FACPAC Contract Change Order Supplemental Information Form (Ref# 64868)

Tier 1 Project: CHHS Phase 2

CHANGE ORDER NUMBER: 6-6
INITIATION DATE: 4/24/2026

ASI NO: Phase 2, 002

A portion of Sheet A-371, Elevation H is shown below. A hand sketch relating to this ASI is labeled **Detail A** and shown on the next page.

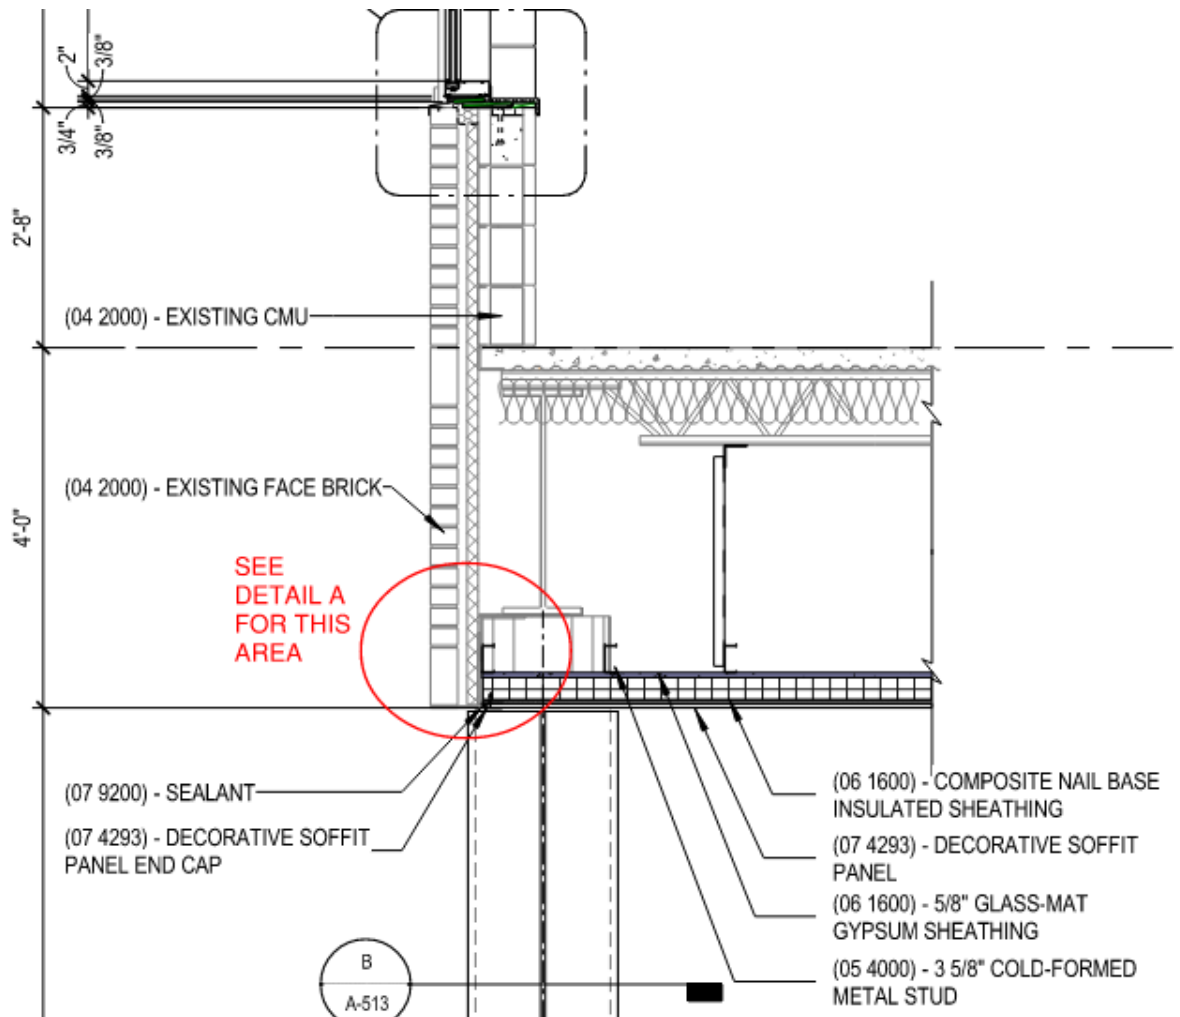
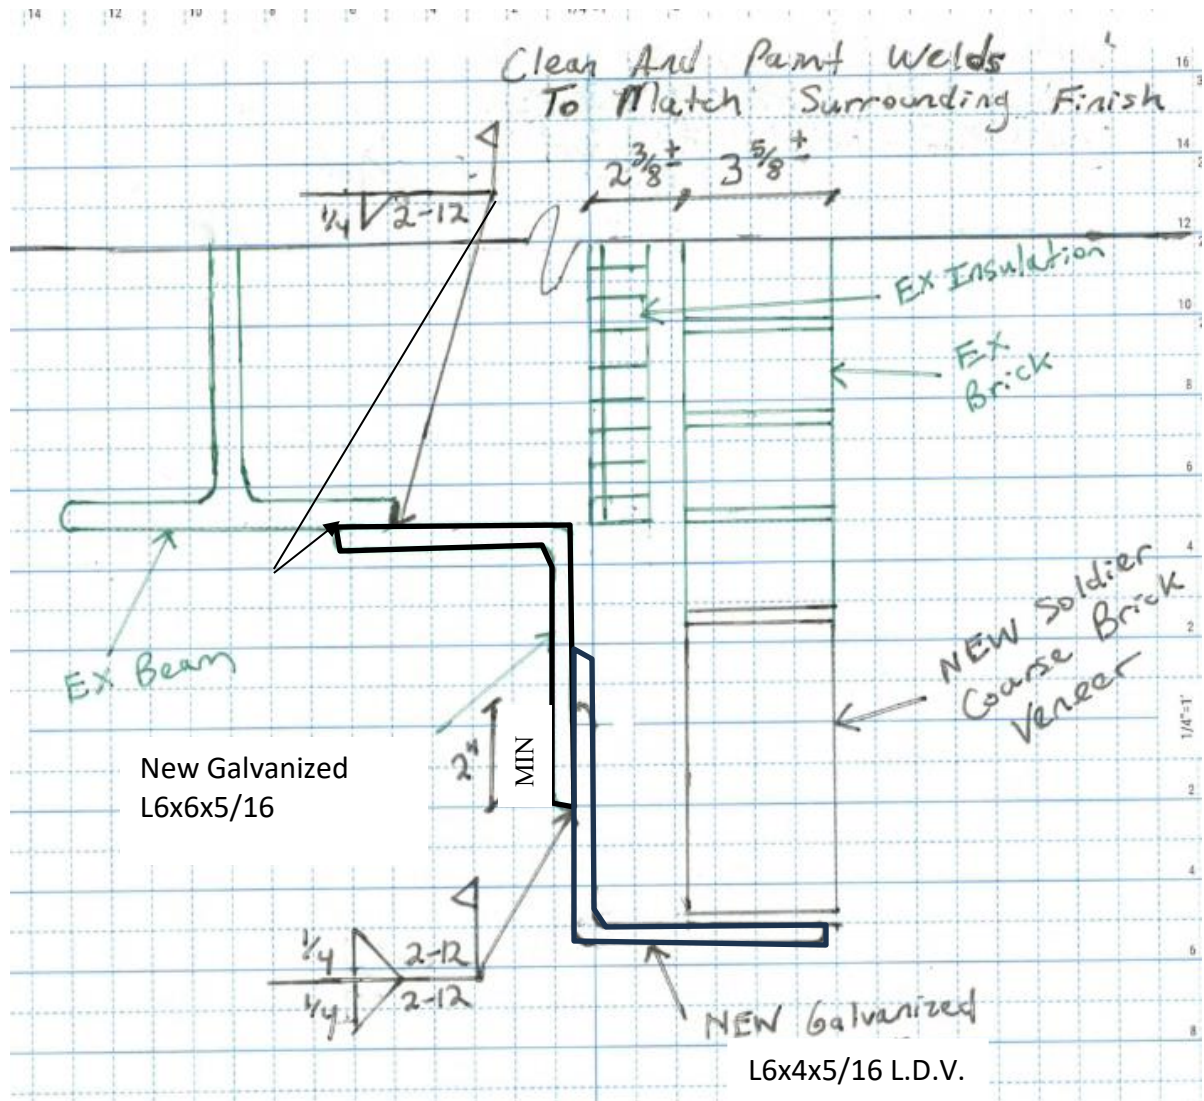
Field investigation and review of attached photos indicate that the existing edge angle supporting the brick veneer is in unsatisfactory condition due to water infiltration within the cavity. Water accumulation has led to significant corrosion of the edge angle, along with the failure of the top weld connecting this angle to an upper supporting angle that is welded to the existing structural beam. These welds are crucial for ensuring proper load transfer of the brick veneer into the structural beam and pose a threat to public safety in their current condition.

Contractor shall carefully remove and replace the existing soldier course of brick veneer and support angle system in four-foot segments, utilizing adequate shoring below the relief angle on each side of the cut-out sections to provide support to the brick veneer (and prevent overloading of the brick ties due to gravity selfweight). Remove brick soldier course and relief angle only over the width of the segment to allow the veneer above to arch between the shoring. Work may be simultaneously performed in a skip pattern of alternating 4 foot sequences; do not demolish adjoining sequence until new mortar is cured. New angles shall be galvanized, L6x4x5/16 (bottom) + L6x6x5/16 (top) and welded to the existing and to the existing steel beam with fillet welds. New flashing with a drip edge, weeps, and ties shall be installed. See **Detail A** for a detailed sketch of the proposed work. See **Appendix A** for elevation views of repair locations (to be three sides of terrace at Area J).

- *Contractor shall field verify dimensions*
- *All steel shall be galvanized and prepared according to Recommended Practice for Providing High Quality Zinc Coatings (Hot-Dip) on Assembled Products (ASTM A385).*

NOTE: NEW SOLDIER COURSE BRICK VENEER AND ANGLES MUST BE REPLACED IN 4 FOOT SECTIONS. WORK MAY BE SIMULTANEOUSLY PERFORMED IN A SKIP PATTERN OF ALTERNATING 4 FEET SEQUENCES; DO NOT DEMOLISH ADJOINING SEQUENCE UNTIL NEW MORTAR IS CURED. CONTRACTOR IS TO ENSURE ADEQUATE SHORING IS IN PLACE TO PREVENT THE TRANSFER OF ADDITIONAL LOAD INTO THE EXISTING BRICK TIES.

REFER TO WALL SECTION A/A-361

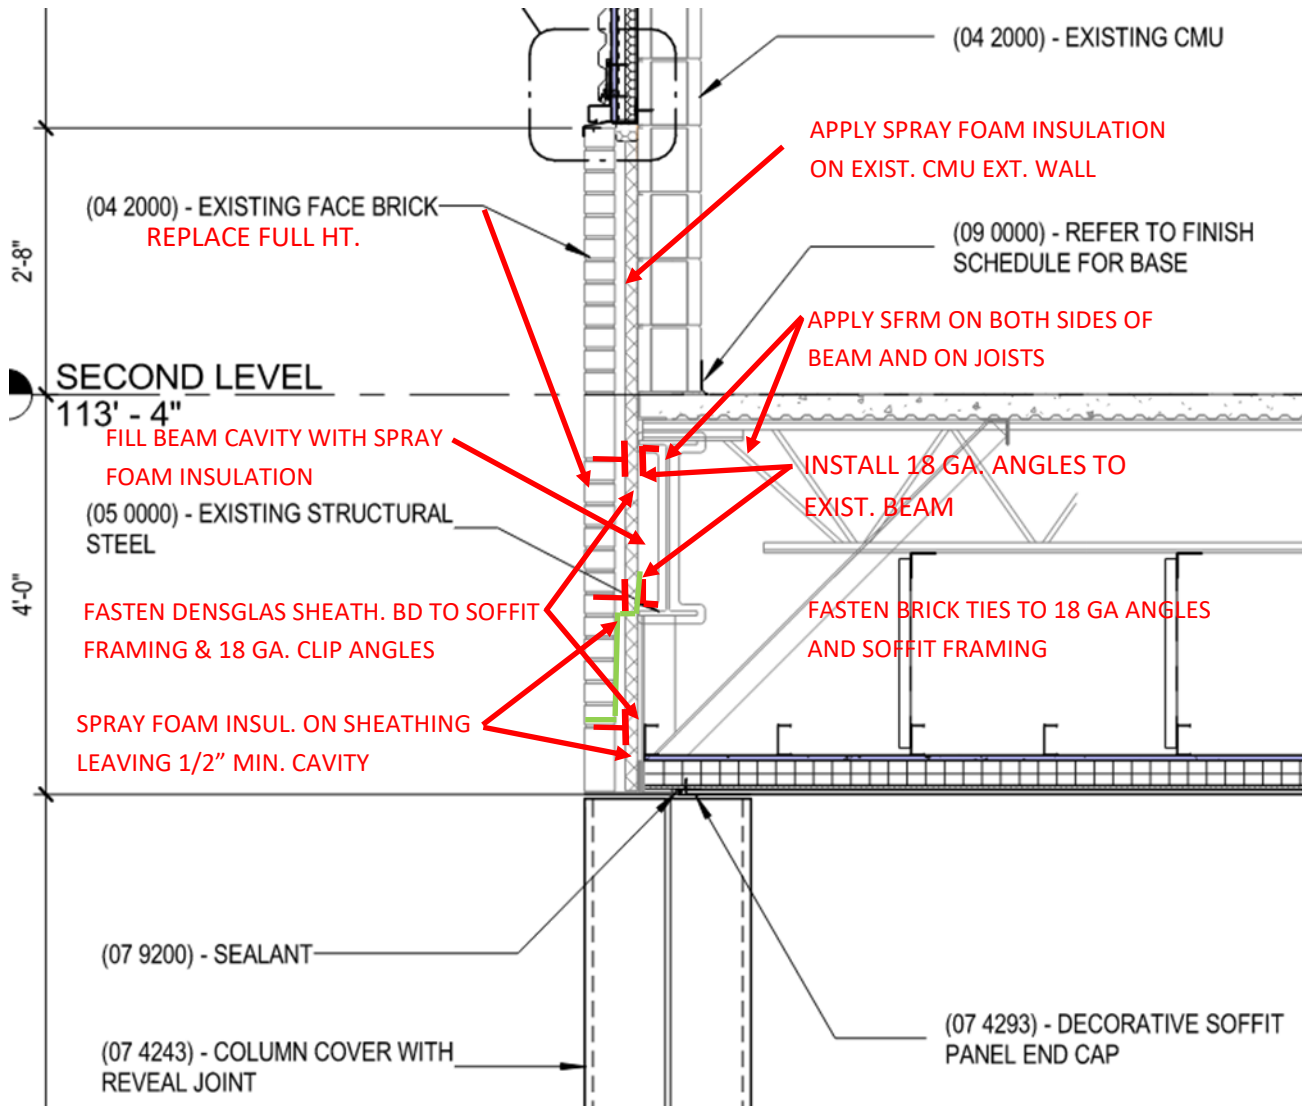
Provide pricing as noted in attached detail for brick and support angle at overhang in Area J.

We propose to provide all labor, material and equipment necessary to add 5/8" National eXP sheathing from the bottom of the existing steel beam to the metal framing of the new ceiling below.
